Top Photo was taken by myself, 4-25-12 looking east across Pinchot Brook S010 and associated wetlands. The wetland crossing is 505' long and waterbody is 42' wide. The other 2 photos I scanned from the Wetland Delineation report NEUP Loop 323 "Site Photographs" Photo 1 (top photo next page) "Northeast view of W036, also associated with S010." Photo 2 (bottom photo next page) "South view of S010, Pinchot Brook also associated with W036." Look carefully all 3 photos taken from the same spot. I feel this is inaccurate information during photographing site locations whether it was intentional or not. The one "Y" tree left center first 2 photos and right center is what I used to determine both photos in Wetland Delineation Report are the same view. These pictures are in the TGP report. My photo you are looking across the "existing" ROW. The new ROW will clear 100' to the left in this photo or basically all the trees on the left in photo. Temporary Work Space and Additional Temporary Work Space are not "temporary" impacts! Note the ROW being used by off road vehicles.

During my pre-construction monitoring and photo documentation of the NEUP I have the following comments from observation

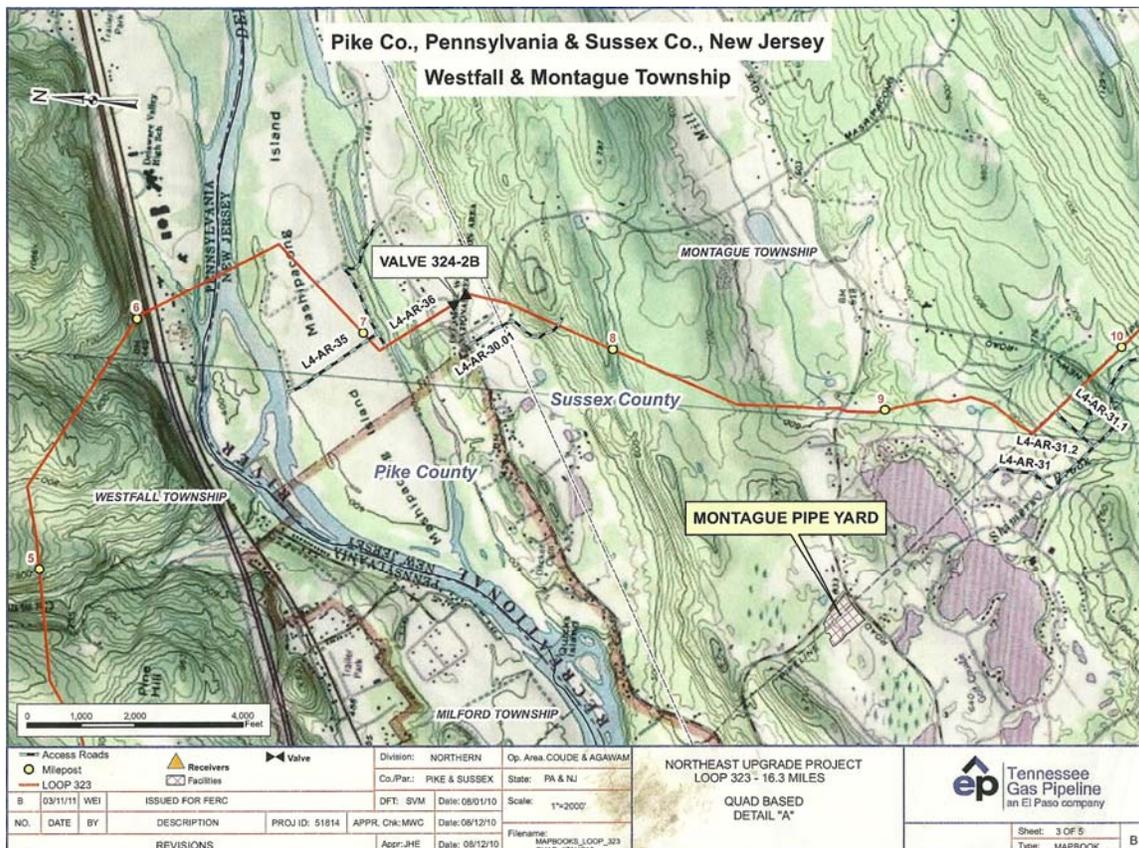
Table 2.2-2 states that L4-AR-35 “accesses Mashipacong Island and the Alternate row leading to the Delaware River directional drill site.” Map from wetland delineation report for NEUP shows AR-35 going directly to the recently approved water withdrawal site bisecting Mashipacong Island and does not go to the Delaware River crossing further up stream. NPS.Gov map includes the 2 islands on the northern boundary within the DWNRA directly across from the approved withdrawal site in a channel of the River. Note TGP’s map is inconsistent with the boundaries on the NPS map and has no access road going to the Delaware River Crossings.

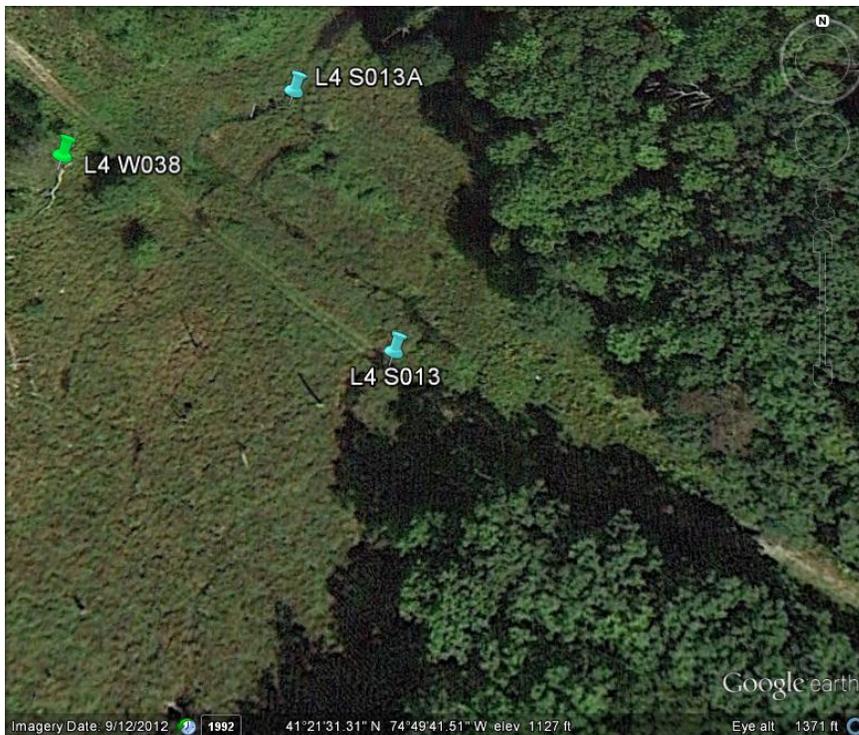
L4 W036-crossing length 504' (NPAB) observations in field have wetland ID signs L4 W036 at mp 0.17 and mp 0.35 or 0.18 miles which equals 950.40' this was confirmed with alignment sheets (PDF 20120808-5072 (274769000)) page 20/45 and notes provided. "9+47 entered wetland L4-W036" "18+51 exited wetland L4-W036" this information was included on stakes identifying TWS down the center of existing 24" pipeline Note the first number represents 100' increments from the start of the NEUP so 9+00 to 18+00 would be 900 ft

Areas approaching S010 (Pinchot Brook) and east of S011 (UNT Pinchot Brook) before the Existing Permanent Easement (EPE) is adjusted from 100' to 50' measurements from EPE to ATWS range up to 200' Field measurements 1/30/13- south-north across ROW on DCNR lands (Delaware State Forests) 100' to EPE + 53' to center of pipeline + 50' to northern EPE 200' photo shows tape stretched out 200' from southern most flagging for TWS to the northern extent of EPE (white and yellow flagging) 25' of EPE is in forested area but still 175' from northern edge of cleared ROW to back line of TWS.

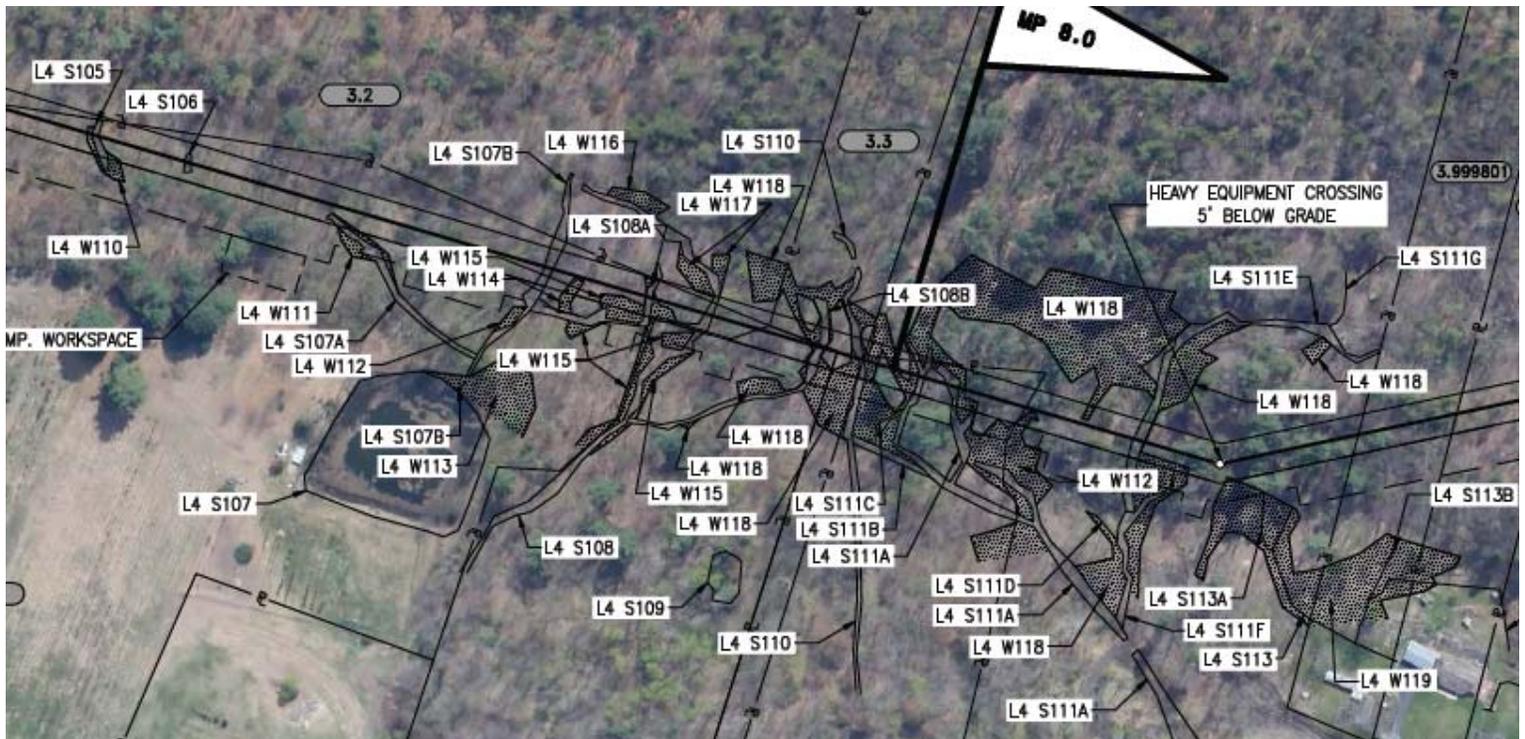
Here's a partial copy of the alignment sheet for the Montague section off of Mountain Road. I walked to where I could see the turn in the ROW (Heavy equipment crossing 5' below grade) Note how complex this section is. I observed and photographed 4 wetland signs and 7 Waterbody signs (one w/no ID at spring house but believe its S105 (Sensitive Resource signage in place) Where there were Wetland Boundary signs there were no delineation flagging and hard to tell where most started or ended or how wide the crossing actually is. The permanent easements were also poorly marked.

The total footage from alignment sheet from S105 to W119 416+21 to 432+08=1587' add up the wetland footage from 7 wetlands W118 crossed 4 times)=785' or just shy of 50% of total length are wetland crossings plus from the alignment sheet there are 9 stream crossing with 11A being crossed 2 times. My observations are; this section is just about all wetlands from bottom of hillside to the TWS for 0.3 miles and alignment sheets confirm at least half the distance is wetlands plus numerous streams.

FYI- I can count 8 different L4 W118's on alignment sheet but failed to observe any resource signs during my field visit on 2/08/13. The alignment sheet had 4 W118's listed. The approved access road AR 30.01 was installed but on the end where it meets the pipeline and not at the intersection of Mountain Road and River Road...the coordinates are given at the end where it meets the pipeline. I would hope these Environmental Inspectors would have the common sense to place it at the turnoff of River Road and not where it meets the pipeline. Guess not?

Report 041-1 Field Visit 3/7/13 AR 10 DCNR Property

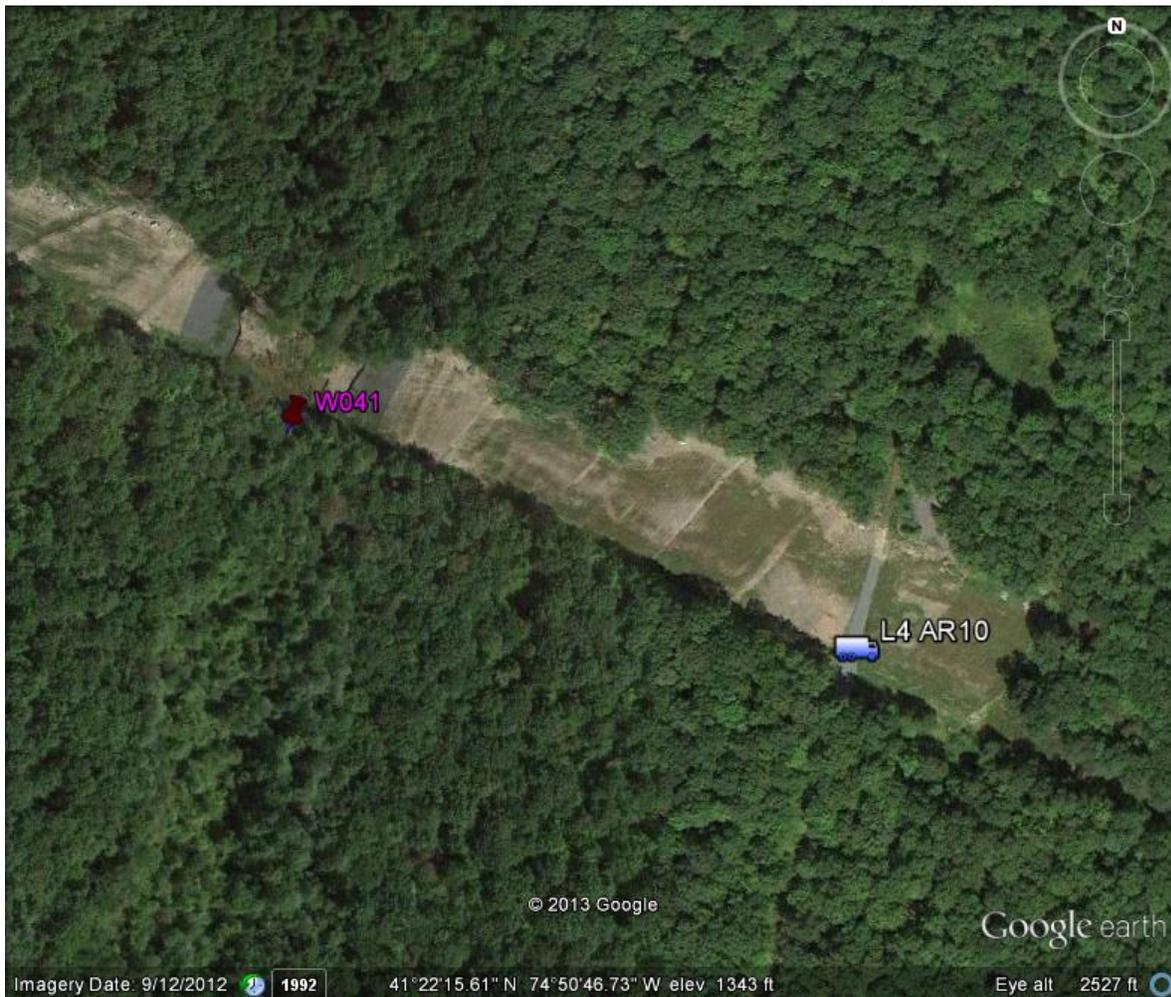
Google Earth image 9/12/12 is of where the 300 Line ends (mp 14.9) and the NEUP starts (mp 0.0) at AR10 (grey strip). November 6, 2012 measurements were taken at several locations with help by a volunteer monitor. Wetland W041 boundary markers can be seen as black strips (E&S controls) measurements taken tree line to tree line.

TGP Environmental Construction Plans call for a workspace reduction of 75' at wetland boundaries; however measurements taken in the field on 11/6/12 had measurements of 146' and 140' at E&S controls still in place marking wetland boundaries at W041 and 103' across the center. Note the reason for E&S controls still in place as of 3/7/13 on Loop 323/300 Line is it is still in "Temporary Condition" associated with construction 15 months after the pipeline went into operation November 2011.

My field observations and measurements indicate the Row as it currently exists is much larger at W041 and AR 10 then the permitted width in the ECP 2.0 Site descriptions. With plenty of workspace already cleared TGP encroached on the 300 Line and felled another 50' x 150' of trees for TWS outside of the Permanent Easement. TGP encroached on the NEUP by approximately 300' x 200' during construction of the 300 Line and cut an additional 50' of trees for TWS for the NEUP project making the total width approximately 250' of workspace.

CP11-161 20120808-5072(27476900) Appendix C

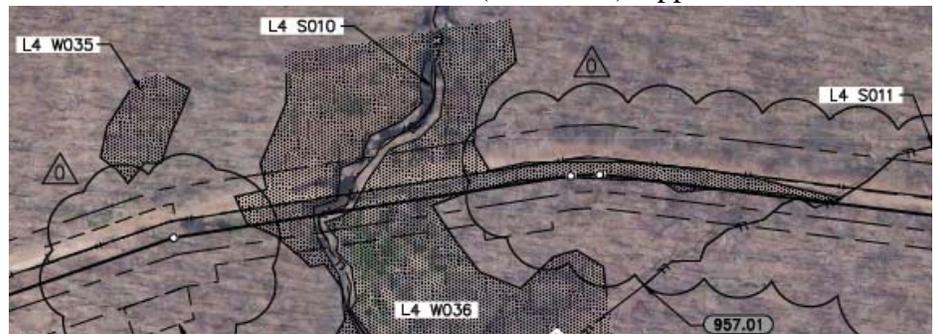
The shaded area of alignment sheet is W036 that has resource signage at 903' apart. Pa Bulletin has a 505' crossing of W036 by TGP. The greenish area (wetland area) in ROW just left and outside of W036 shaded area would support my conclusion that signage for W036 is not accurately installed or delineated with my field observations.

DRN Photo 100_4955 looking north Sawmill Rd

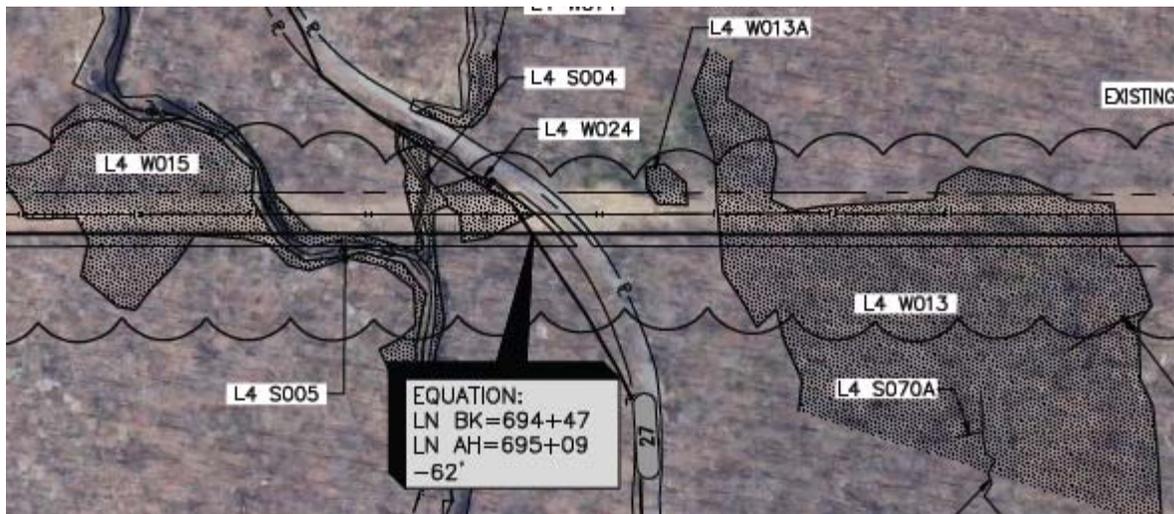
Photo 100_4955 shows the existing 24” line on the other side of my car and a 200’ tape measurer stretched out to its maximum length. Photo 100_4983 shows the existing ROW to the far right of photo the 24” line is on the other side of my car. TGP cut a “new” ROW (estimate 100+ feet and several hundred feet deep) off the existing ROW leaving a narrow strip of trees where the alignment sheet shows the narrow construction ROW. The alignment sheet shows the 30” line to the north of the big bend of Big Flat Brook (S005) but it is actually to the south and approximately 100’ wide where it crosses the Big Flat Brook.

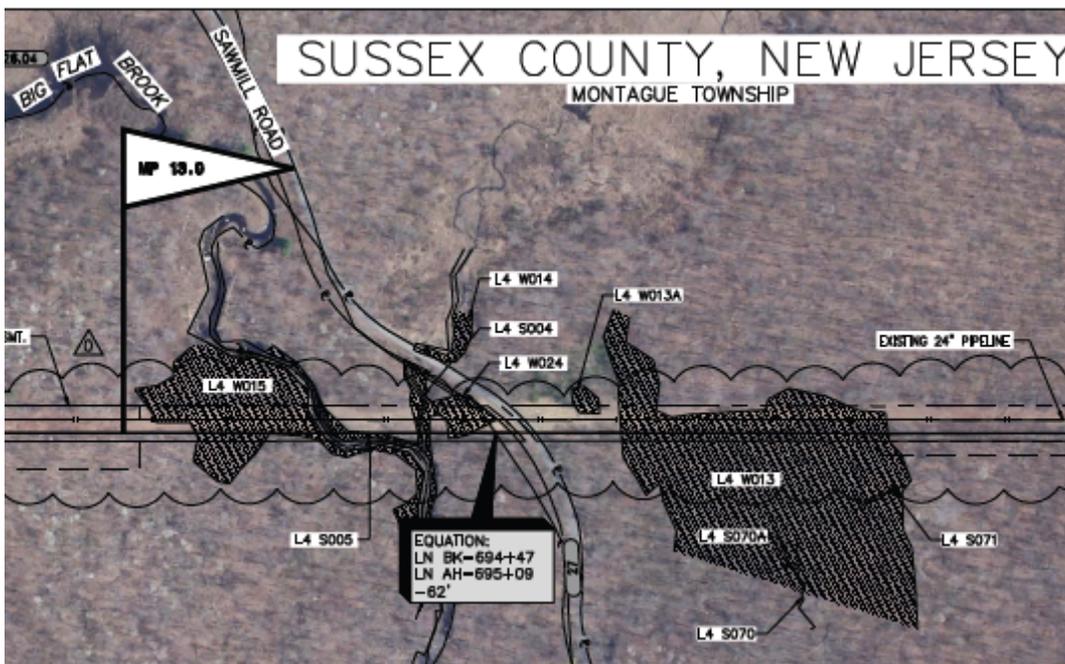
FWW Permit Environmental Report October 2011 Appendix C Table 2.2-9 “Waterbodies associated with the NEUP in NJ Loop 323” has L4 S005 Big Flat Brook mp 13.13 associated with W014. Table 2.3-7 “Wetlands associated with the NEUP Loop 323” does not have L4 W014 listed as a crossing but is shown on alignment sheet and crosses the pipeline ROW.

Alignment sheet also shows L4 W024 is entered at 693+61 and exits at 695+14 Table 2.3-7 does not list L4 W024 as being in the project area.

L4 W013A has resource signage in the field but not in table 2.3-7 or on the alignment sheets.

Resource signage in place and on the alignment sheet for S004 but not listed in Table 2.2-9 of FWW Permit

Appendix C alignment sheet page 33/45 Parker Brook west to Ridge Road crossing.

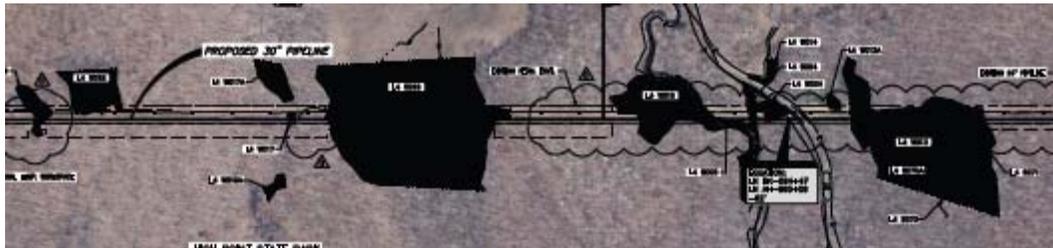
A complete new ROW was cleared even though the new pipe is crossing under the next to the existing pipeline. I believe several wetlands have be compromised and not listed on the FWW permit. Resource signage was in place and not on the FWW permit in this area. The large disturbance is located along S005 Big Flat Brook that has the July 1-May 1 timing restrictions. Open pits from the boring with inadequate fencing along the State Park Road on a Holiday weekend. Top soil looks like wetland soils grubbed up...appears to have a considerable amount of tree debris mixed in. Other photos show the additional construction workspace/ROW where it co-locates with the existing pipeline further to the west.
